**KNOX COUNTY HISTORIC ZONING COMMISSION
STAFF REPORT - CERTIFICATE OF APPROPRIATENESS APPLICATION**

PROPERTY ADDRESS: 10817 Second Dr 37934

FILE NO.: 2-F-18-HZ

LEVEL OF WORK: Level III. Construction of new primary building

South Elevation (Garage)

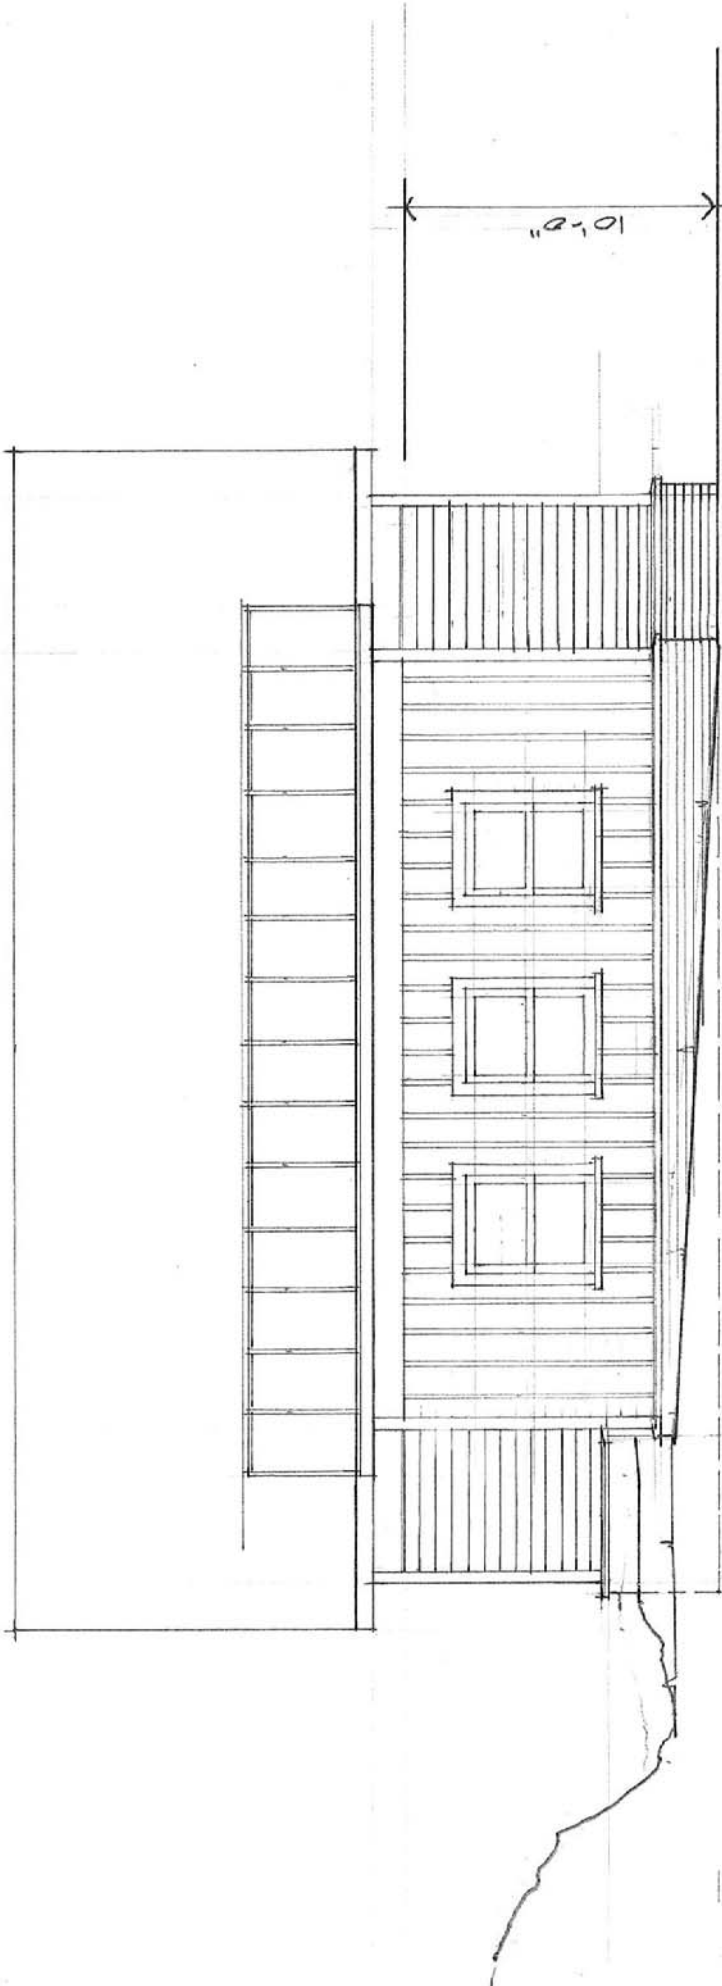
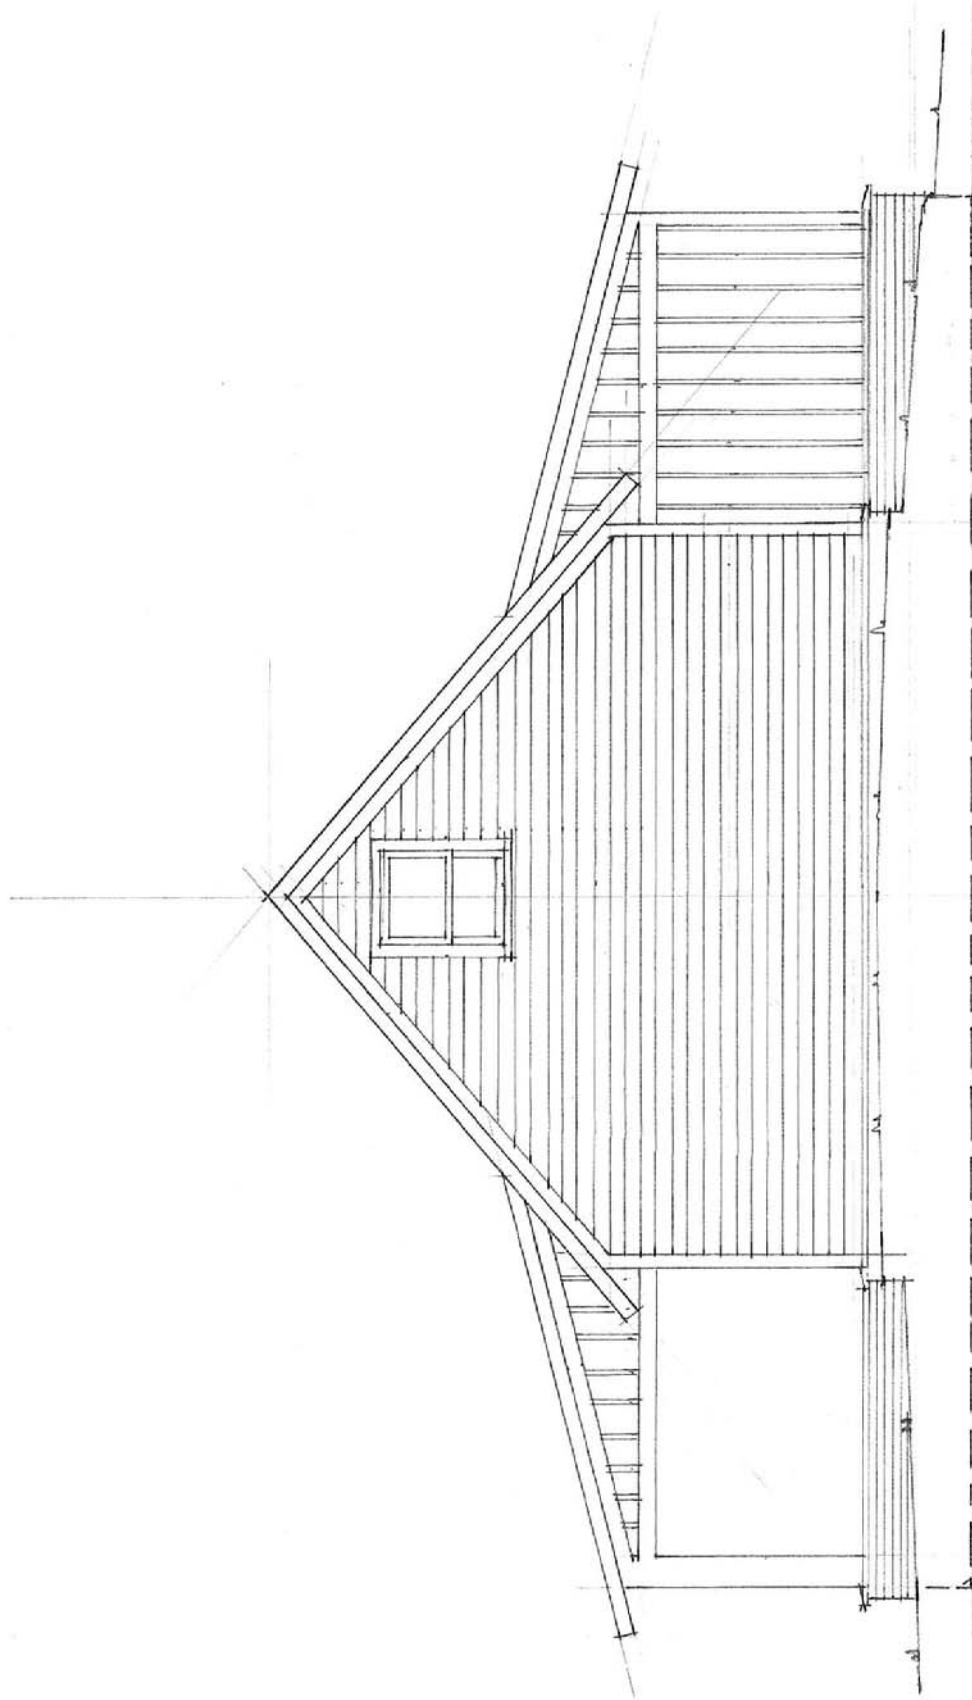
- 1) that the garage door openings be two separate ones as shown in the drawings and overhead doors to appear as side-opening carriage house doors. Confirmation of service door type (shown as single-light or single wood panel

3) The garage peak should be made to be more significantly lower than 1 foot than that of the house since no precedent has been discovered by staff or provided by the applicant for accessory structures that are nearly the same height as the main house.

door on submitted drawings) with specifications for both to be provided to staff for approval.

Garage door proposal and recommendation for 10817 Second Drive

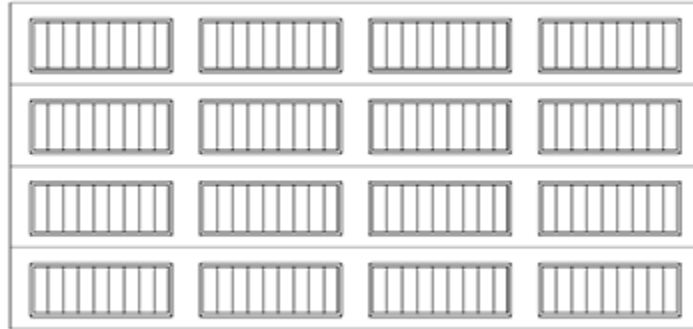
16 –foot long panel single-door design steel door proposed by applicant

Staff recommended garage door hardware with hinges and handles providing the appearance of two sets of more narrow side-opening doors.
(May be with or without windows and may feature a “long panel design”.)
